# SERVICE BULLETIN

AT95-004

## 1995-1996 MAXIMA A/T KEY INTERLOCK CABLE

**APPLIED VEHICLE:** 1995-1996 Maxima (A32)

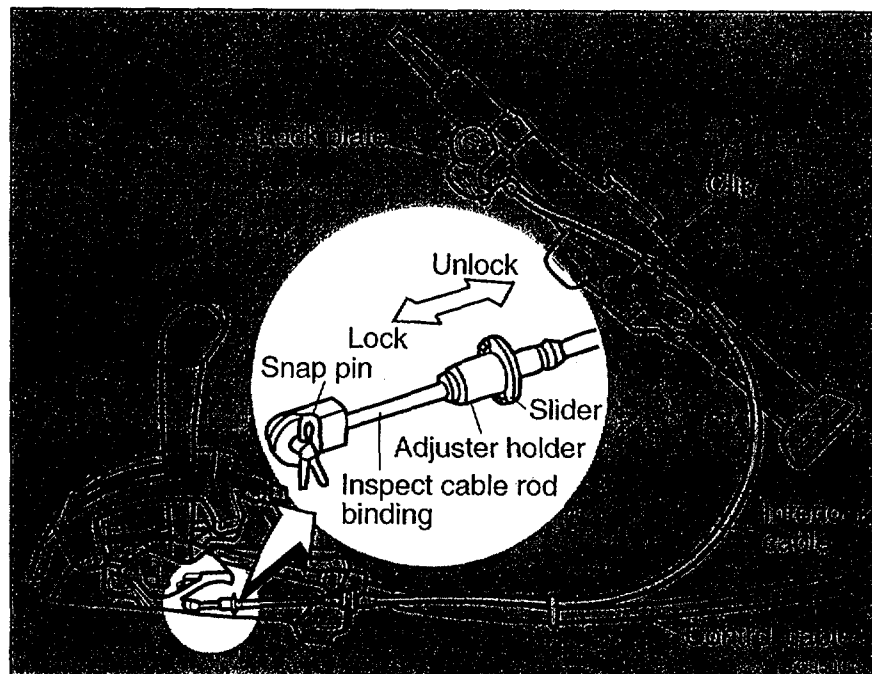
Customers may complain that the automatic transmission shift lever cannot be moved from Park under hot ambient conditions. The incident may occur more frequently when the vehicle is parked in direct sunlight. A new A/T interlock cable has been developed to reduce internal friction under hot ambient conditions.

1. After duplicating the incident, isolate whether the shifter or interlock cable is the cause of the incident. Disconnect the interlock cable from the shifter. If this does **not** resolve the incident, the problem is in the shifter.
2. Check for proper shifter solenoid operation, bent/broken parts, and evidence of spilled liquids (juice or soda). Repair/clean components as necessary and recheck operation.

3. If the incident is resolved in step 1, reconnect the interlock cable to the shifter and disconnect it from the ignition key. **If the incident returns**, the cable may be damaged and/or have excessive internal friction.
4. Replace the A/T key interlock cable with the part number listed in this bulletin. Refer to pages AT-122 in the 1995 Maxima Service Manual and A/T-121 & 122 in the 1996 Maxima Service Manual for proper cable removal, installation, and adjusting procedures.
5. Recheck interlock cable operation under the same ambient temperature conditions that the incident originally occurred.

**Do not** twist the adjuster holder when performing the cable adjustment. Twisting of the adjuster holder can increase internal friction of the cable and increase the risk of the shifter becoming stuck in park.

After cable replacement, ensure that the shifter **cannot** be moved after the key has been removed from the ignition. If the shifter can be moved without the key in the ignition, lengthen the cable adjustment and recheck.
